UNITED STATES PATENT AND TRADEMARK OFFICE

Office Action Summary	Application No. 10/840,145	Applicant(s) LASEE, JACK C.	
	Examiner William V. Gilbert	Art Unit 3635

DETAILED ACTION

This is a non-final office action. Claim 8 has been cancelled.
Claims 1-7 and 9-20 are pending.

**Figure 5 from Stark**

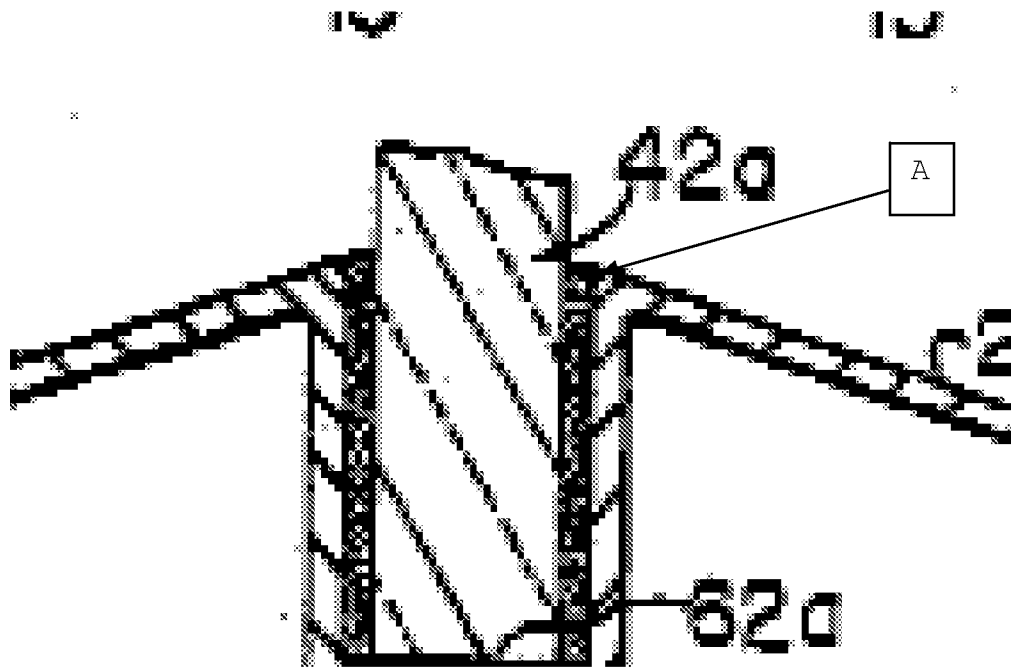
Claim 1: Stark discloses a window panel comprising first and second flange units (Fig. 5: 22a, 20a, respectively) each comprising a preassembled rectangular frame (Fig. 1, generally), sash elements (32a, 28a, respectively) that extend into the opening to capture a transparent pane (42a), at least one retention member (52a) attached to the first flange unit and extending into the opening to grip a sill surface (64a) to retain the first flange unit (22a) and the sash element in position for assembly, and at least one fastener (15a) adapted to draw the first and second flanges and the sash elements together against the pane, the sash elements include inwardly spring biased sharp edge portions (see "A" from attached Fig. 5 from Stark, below, and the edge portions are spring-biased via

fastener, 15), and the elements are spring biased via fastener (15a) in contact with the pane and the edge portion would embed in the pane when the pane is in a semi-molten state. The language "wherein said sharp edge...semi-molten in fire" lines 13 and 14 are steps that relate to a desired result and the examiner contends that as a glass pane becomes molten, it will inherently soften which would result in virtually anything imbedding in the pane if a force (such as a spring bias against the sharp edge) were applied to it. Regarding the limitation "preassembled", the limitations are drawn to method steps and only the final product, the apparatus, is provided patentable weight.

Claim 7: the opening is rectangular (Fig. 1) having four sill surfaces and the vision panel has four retention members (see Fig. 4, generally), attached indirectly to the first flange unit and extending into the opening to grip all four sill surfaces.

Claim 9: a surface of the retention member (62a) supports edges of the pane.

Claim 10: the flange units are straight segments joined at corners by a type of weld fastening (while the prior art notes that the four sides as a single unit, it is four segments joined at the corners).

Figure 2 from LaSee

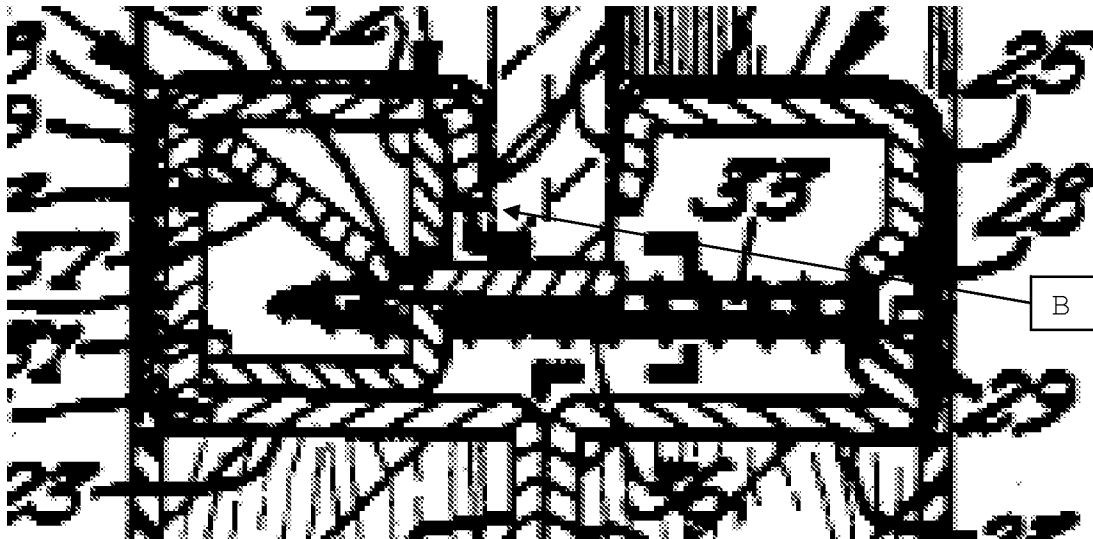
Claim 1: LaSee discloses a vision panel (Fig. 1: generally) having a first and second flange units (25), each comprising a preassembled rectangular frame (see Fig. 1, generally where the frame, portion 18, is a rectangular frame) that abut a front and rear face of the door (10), sash elements (26) that extend into the opening and capture a transparent pane (19) within the opening, a retention member (31) attached to the first flange and extending into the opening to grip a sill surface of the opening to retain the first flange unit and sash elements in position, and a fastener (33) that draws the first and second flanges and sash elements together against the pane, and the sash elements (26) have inwardly spring biasing sharp edges (see "B" from attached Fig. 2 from LaSee, below,) and the elements are spring biased via fastener (28) in contact with the pane and the edge portion would embed in the pane when the pane is in a semi-molten state. The language "wherein said sharp edge...semi-molten in fire" lines 13 and 14 are steps that relate to a desired result and the examiner contends that as a glass pane becomes molten, it will inherently soften which would result in

virtually anything imbedding in the pane if a force (such as a spring bias against the sharp edge) were applied to it.

Claim 3: the fastener is threaded and the second flange unit has a hole (proximate 29) for receiving the threaded fastener and the retention member has a socket (proximate 34) for receiving an end of the threaded fastener after it has passed through a hole.

Claim 4: the socket is attached to the retention member by a spring element (32) that would allow movement of the socket to the second flange unit against a spring bias force.

Claim 5: the spring element (32) is a cantilevered tab, extending across an axis of the threaded fastener that would flex with increased engagement of the threaded fastener.

Claim 19: the sash elements include inwardly biased sharp edges (see "B" above) that would embed in the panel member when the panel becomes semi-molten.

The examiner respectfully disagrees with applicant's interpretation of the "sharp edge portions", and "spring-biased". With regards to the "sharp edge portions", the examiner contends that the portions indicated in the rejection above (with an added figure from LaSee) are sharp edged as each terminates in a point. To claim the limitation that these will embed in the pane when the pane becomes semi-molten in fire relate to method steps and intended use of the member. If the glass in the prior art of record cited above were to become molten, the examiner contends that the sashes would imbed in the glass. Further, the examiner contends that the members are "spring biased" due to the threaded member that holds the two sashes together. The resulting force drawing the two sashes together would result in a spring force.
